**TABLE OF CONTENTS**

**Exhibit A** Proposed Reliability Standard PRC-025-2

## **I. EXECUTIVE SUMMARY**

Proposed Reliability Standard PRC-025-2 adds enhancements to the currently-effective generator loadability standard PRC-025-1, to better address risks of unnecessary generator

**Figure 1:** Generation exported through a single radial line.

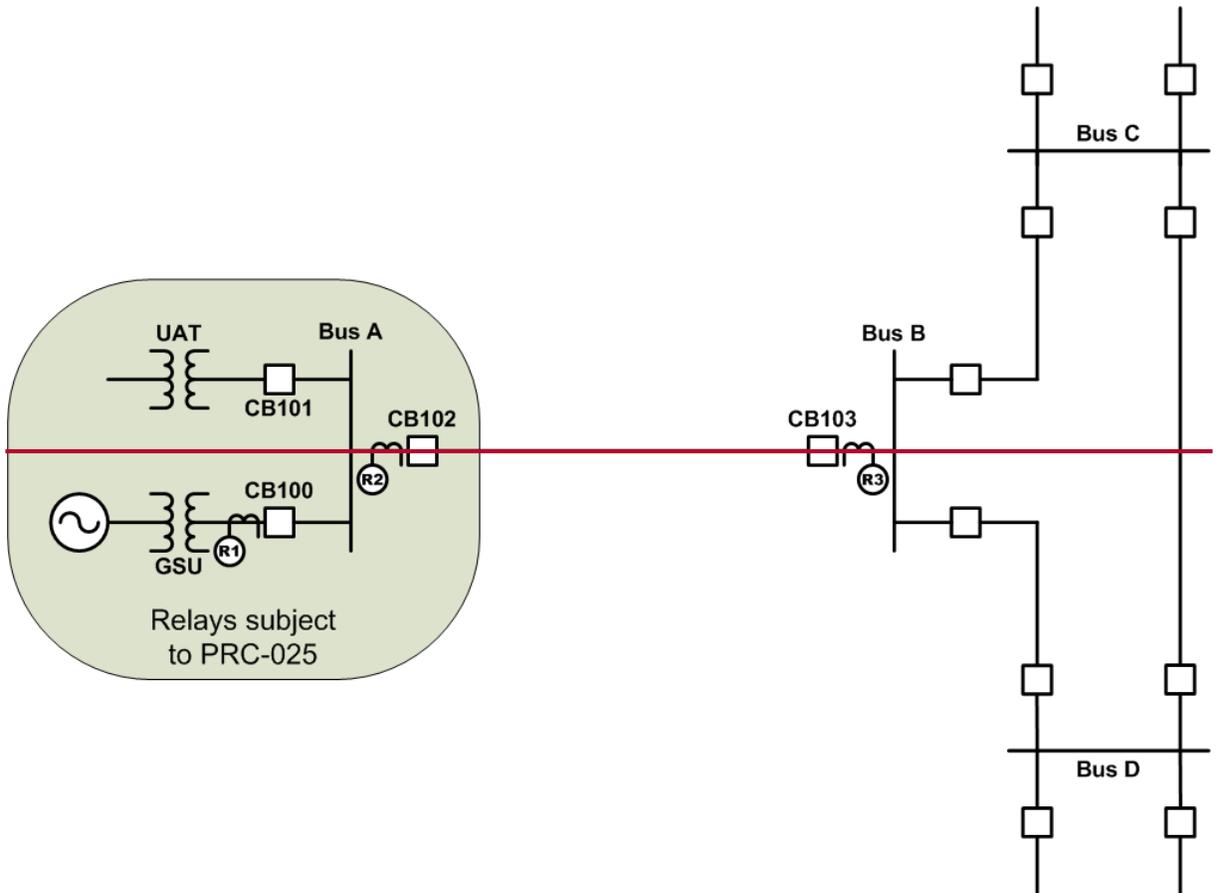
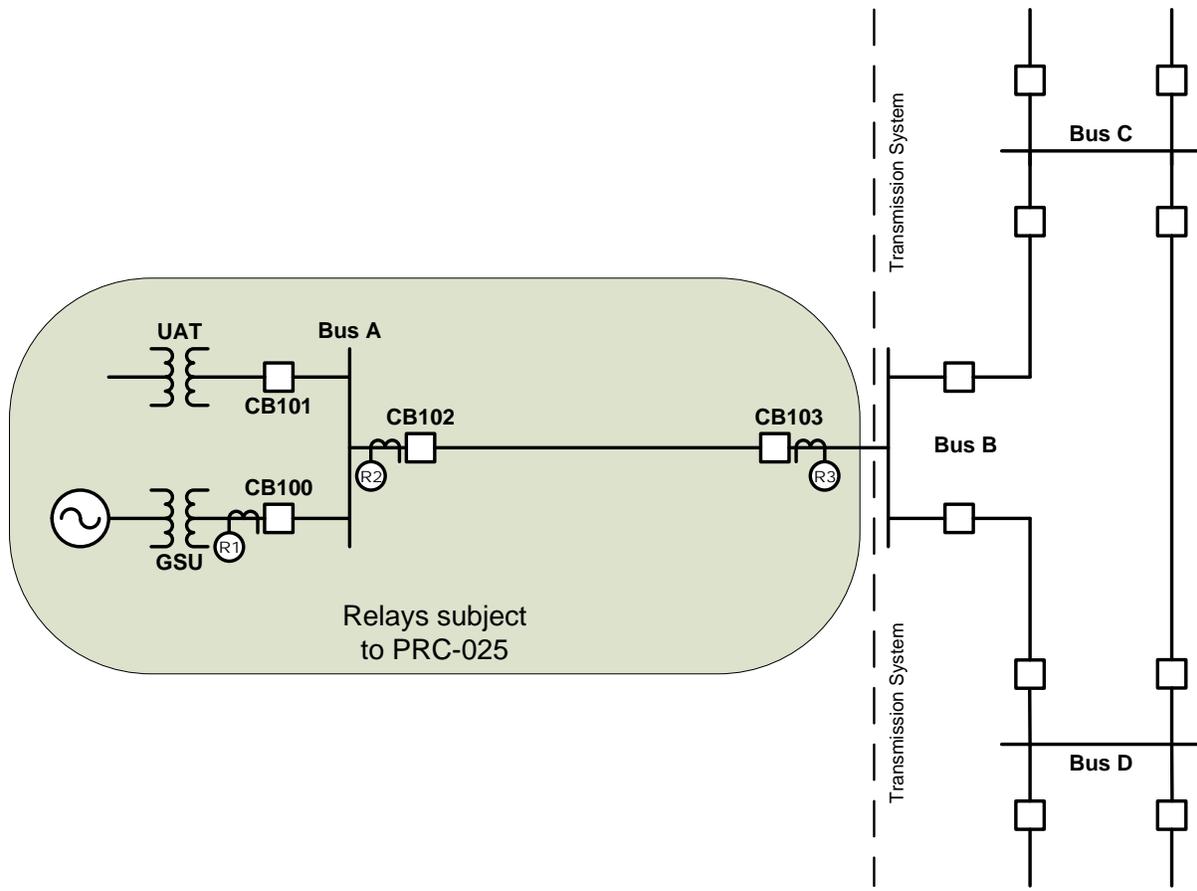
- d. It is not clear that CB103 relay in Figure 1 of the Application Guidelines is applicable to the standard because the Application Guidelines only addresses a directional relay toward the generator plant as not being applicable; however, there are cases where CB103 would be applicable to the standard (e.g., non-directional relays). Provide clarity that would help prevent the overlooking of the CB103 relay as being applicable to the standard, including a potential revision to Figure 1.

- d. Consider clarifying that CB103 relay in Figure 1 of the Application Guidelines is applicable to the standard and correct the figure to show CB103 as also possibly being subject to the standard. The Application Guidelines only addresses a directional relay and that non-directional relays would be applicable to the standard.

**Figure 2:** Generation exported through multiple radial lines.

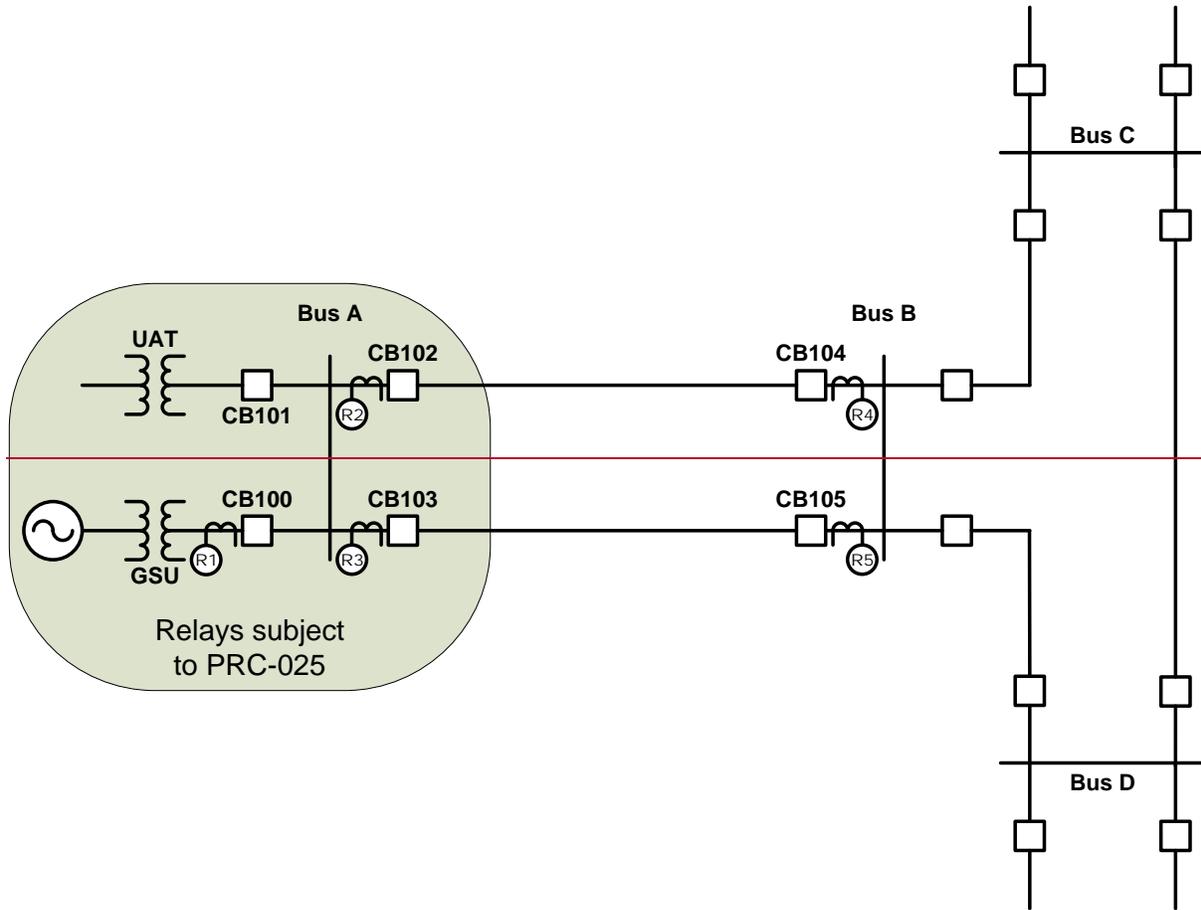
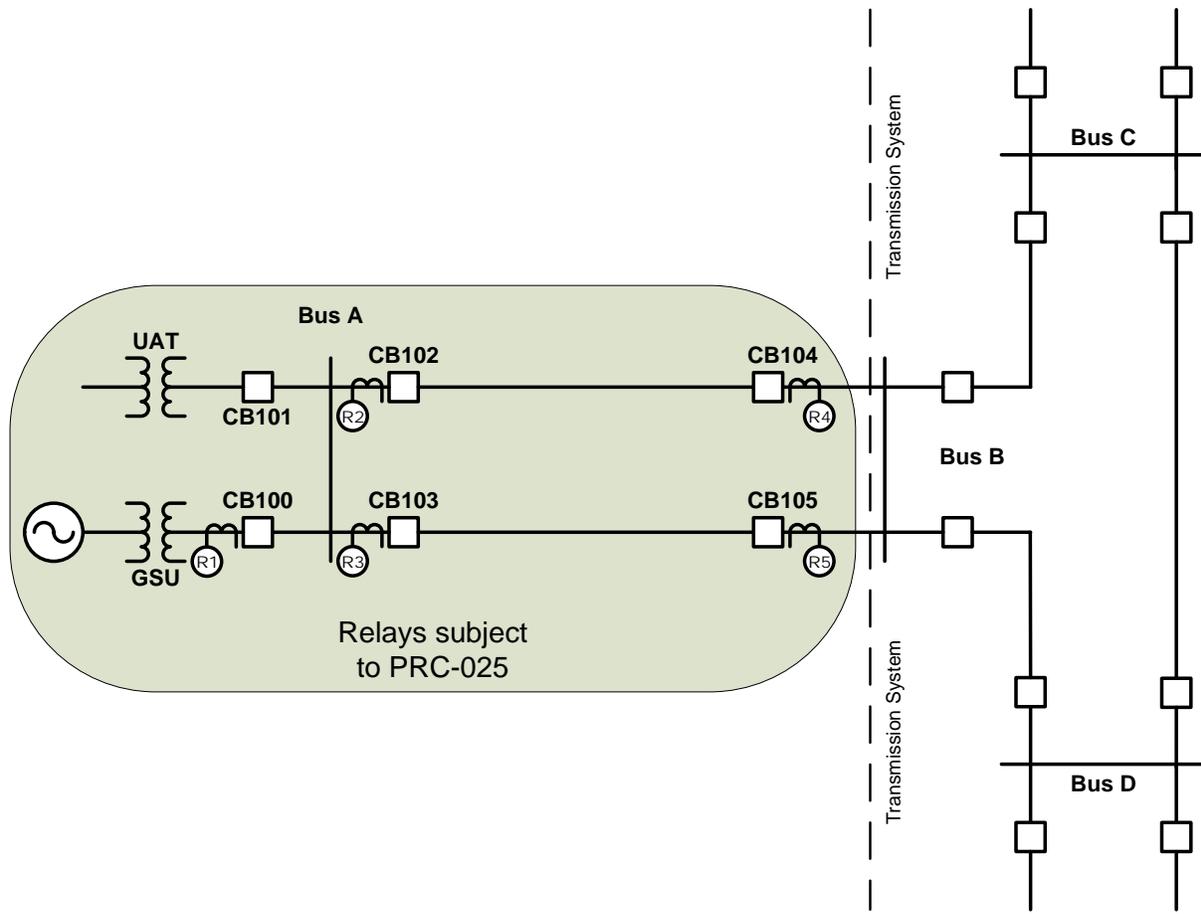
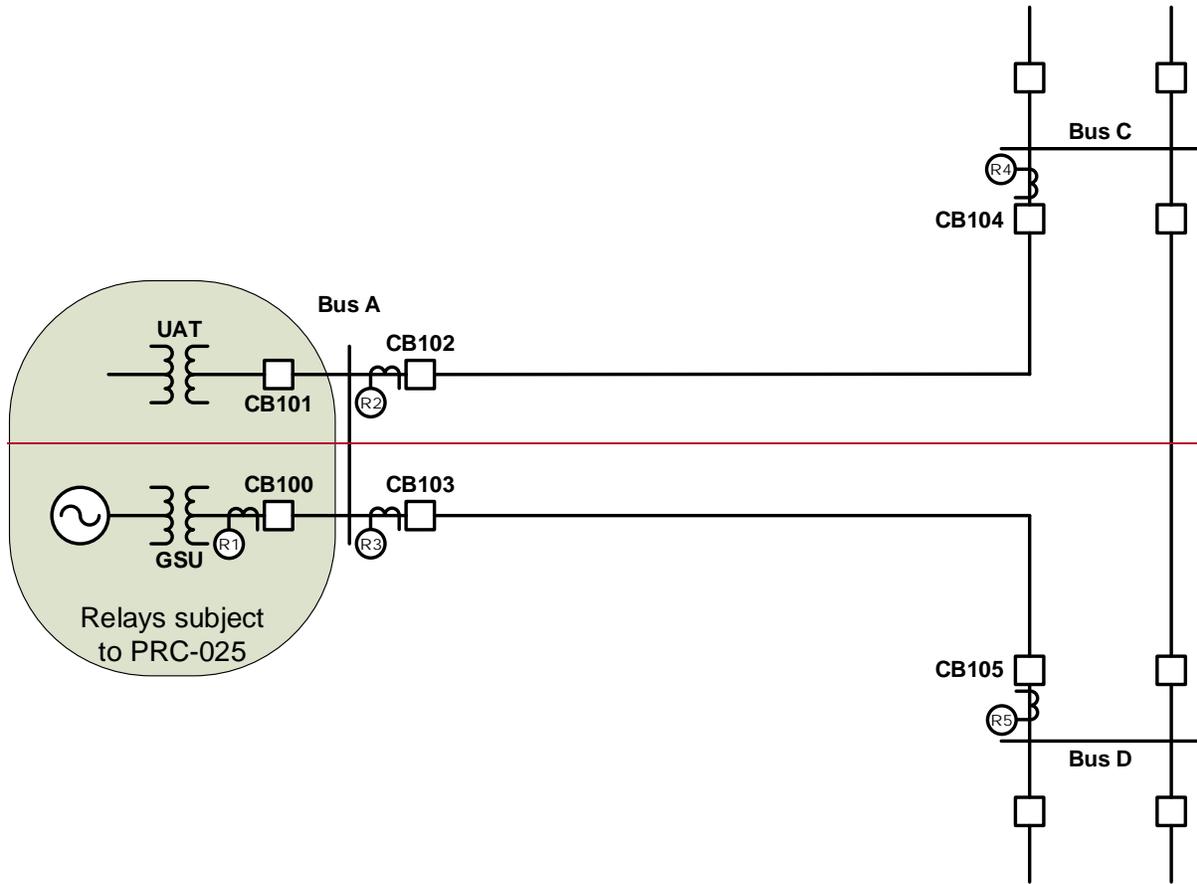
For figure 2, identify that busses B, C, and D and their interconnecting lines as 'the transmission system' for clarity. We believe that this will help clarify that only reverse-looking or non-directional elements are within PRC-025 scope.

Thank you for your comment. The drafting team has updated Figures 1, 2, and 3 with a demarcation line labeled “Transmission System” for added clarity.

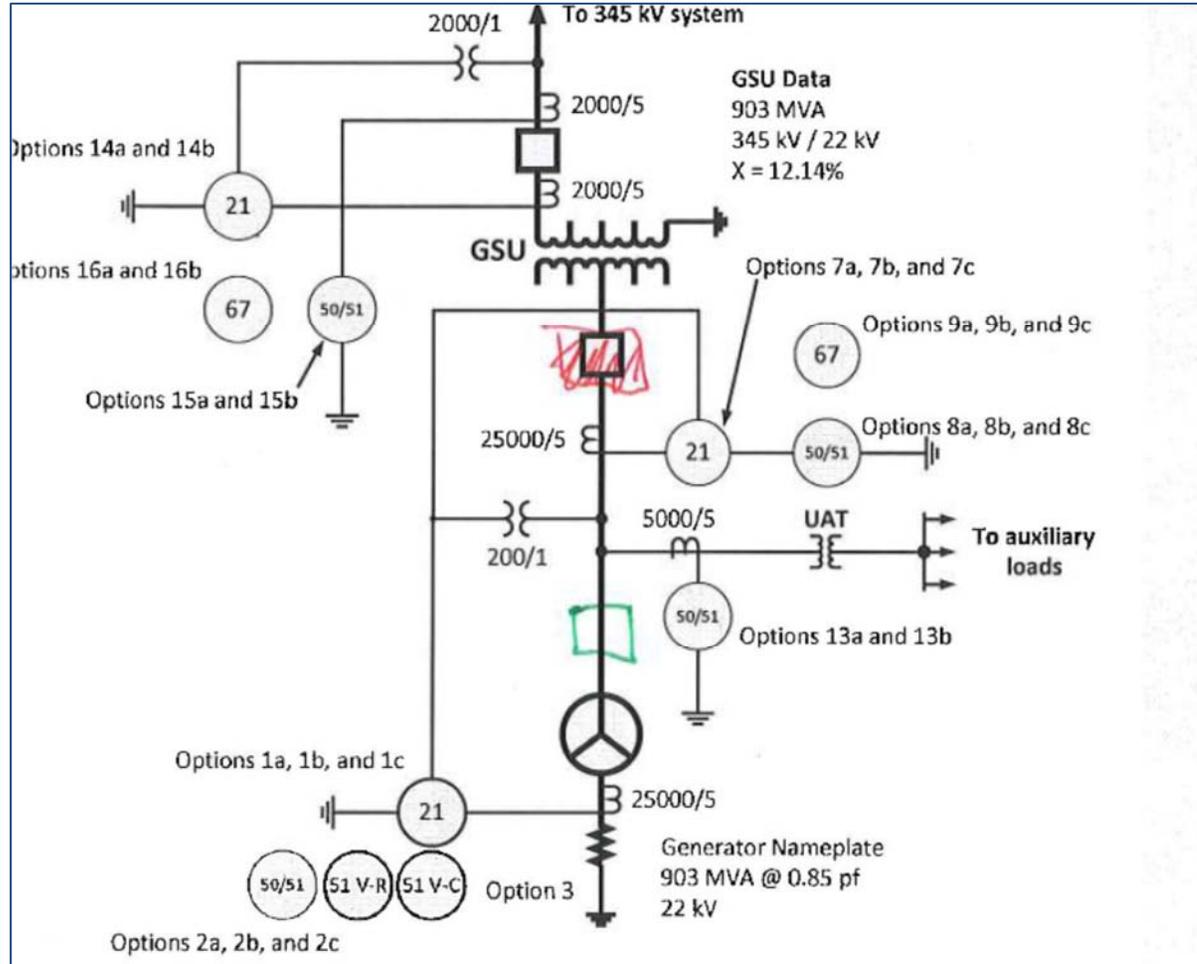
Xcel Energy has concerns that the changes to the "Application" column for Options 7a-7c, 8a-8c, and 9a-9c are somewhat misleading and the description is inconsistent with Figure 5. We do acknowledge that this is partially a carryover issue from PRC-025-1.

The "Application" column for options 7, 8 & 9 describe "Relays installed on the generator side of the Generator step-up transformer..." Figure 5 shows that the current transformers for the load dependent relays to which options 7-9 are applicable are actually applied on the generator or the generator breaker and not specifically on the low side of the GSU. Note that many microprocessor based generator protection relays allow you to select the signal source for the current input to the 21 function such that either neutral or line side current transformers may be used for the current signal input to the 21 device associated with the generator. In other words, not all generator load dependent relays are fed neutral side current transformers. From this perspective, it would be unclear whether the entity should be using option 1a-1c or option 7a-7c for evaluating the loadability of the 21 function or options 2a-2c or option 8z-8c for the 50/51 functions.

Note that on Figure 5, the location of the generator breaker relative to the generator bus tap to the UAT is incorrect for most typical applications. In most applications when a generator breaker is provided, it will be on the generator bus between the generator and the bus tap to the UAT so that the UAT remains in service from the GSU when the generator breaker is open and the generator is offline. There would be operational value in a generator breaker between the UAT tap and GSU LV winding as shown in Figure 5. By moving the location of the generator breaker to the correct location between the generator and UAT bus tap on Figure 5, all inconsistency would be eliminated and would greatly improve the clarity of the differences between options 1 vs. 7 and 2 vs. 8. See attached file for markup of Figure 5.

The representation of the breaker in Figure 5 is for illustration and may not be representative of all configurations.
